NATIONAL FIRE PROTECTION ASSOCIATION

M E M O R A N D U M

TO: Code-Making Panel 13

SUBJECT: NEC® First Draft Technical Committee FINAL Ballot Results (A22)

**Figure Informational Note Figure
700.32 Emergency System Selective
Coordination.**

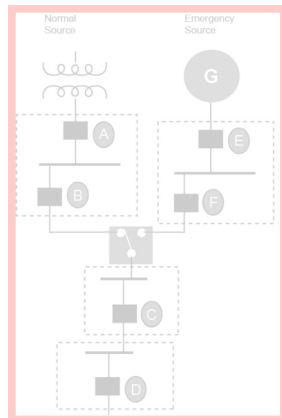
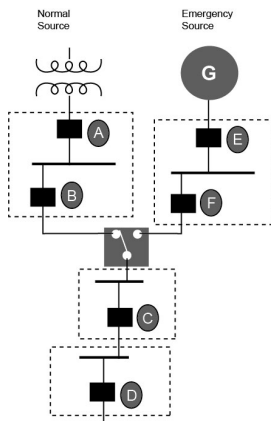
~~Informational Note: See Informational Note Figure 700.32 for an example of how emergency system overcurrent protective devices (OCPDs) selectively coordinate with all supply-side OCPDs.~~

~~OCPD F selectively coordinates with OCPD E.~~

~~OCPD B is not required to selectively coordinate with OCPD A because OCPD B is not an emergency system OCPD.~~

Informational Note: See Informational Note Figure 700.32 for an example of how emergency system overcurrent protective devices (OCPDs) selectively coordinate with all supply-side OCPDs.

OCPD F selectively coordinates with OCPD E.

OCPD B is not required to selectively coordinate with OCPD A because OCPD B is not an emergency system OCPD.

Figure Informational Note Figure 701.10(B)(a) Single or Multiple Feeders Without Overcurrent Protection.

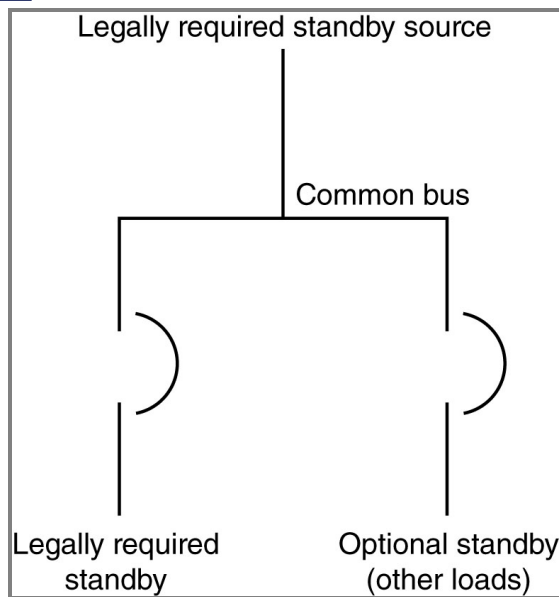
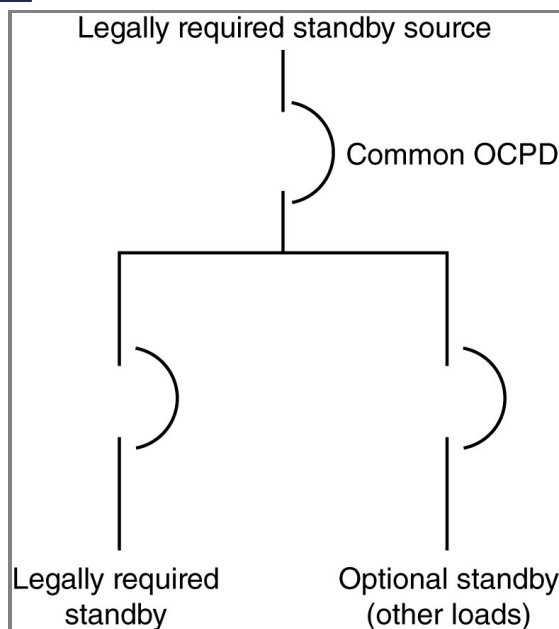
Informational Note: See Informational Note Figure 701.10(B)(a) and Informational Note Figure 701.10(B)(b) for further information.

**Figure Informational Note Figure
701.32 Legally Required Standby System
Selective Coordination.**

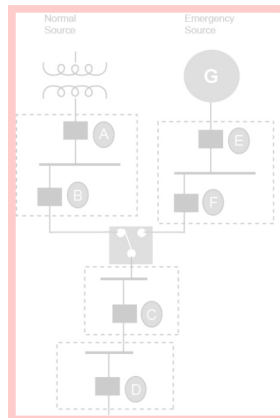
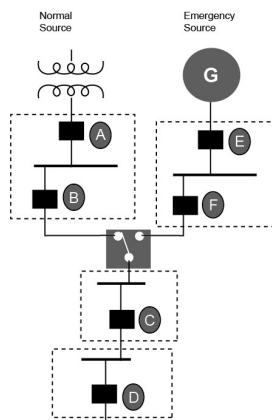
~~Informational Note: See Informational Note Figure 701.32 for an example of how legally required standby system overcurrent protective devices (OCPDs) selectively coordinate with all supply-side OCPDs.~~

~~OCPD F selectively coordinates with OCPD E.~~

~~OCPD B is not required to selectively coordinate with OCPD A because OCPD B is not a legally required standby system OCPD.~~

Informational Note: See Informational Note Figure 701.32 for an example of how legally required standby system ~~overcurrent protective devices (OCPDs)~~ OCPDs selectively coordinate with all supply-side OCPDs.

OCPD F selectively coordinates with OCPD E.

OCPD B is not required to selectively coordinate with OCPD A because OCPD B is not a legally required standby system OCPD.

**Figure Informational Note Figure
708.54 Critical Operations Power System
Selective Coordination.**

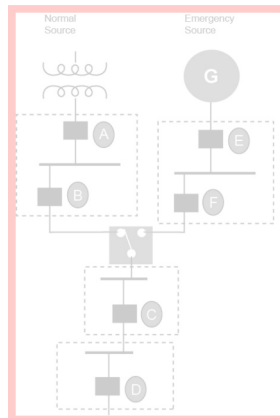
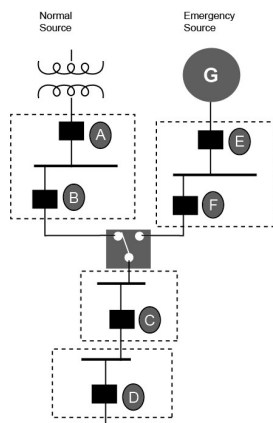
Informational Note: See Informational Note Figure 708.54 for an example of how critical operations power system overcurrent protective devices (OCPDs) selectively coordinate with all supply-side OCPDs.

OCPD F selectively coordinates with OCPD E.

OCPD B is not required to selectively coordinate with OCPD A because OCPD B is not a critical operations power system OCPD.

Informational Note: See Informational Note Figure 708.54 for an example of how critical operations power system ~~overcurrent protective devices~~ (OCPDs) selectively coordinate with all supply-side OCPDs.

OCPD F selectively coordinates with OCPD E.

OCPD B is not required to selectively coordinate with OCPD A because OCPD B is not a critical operations power system OCPD.
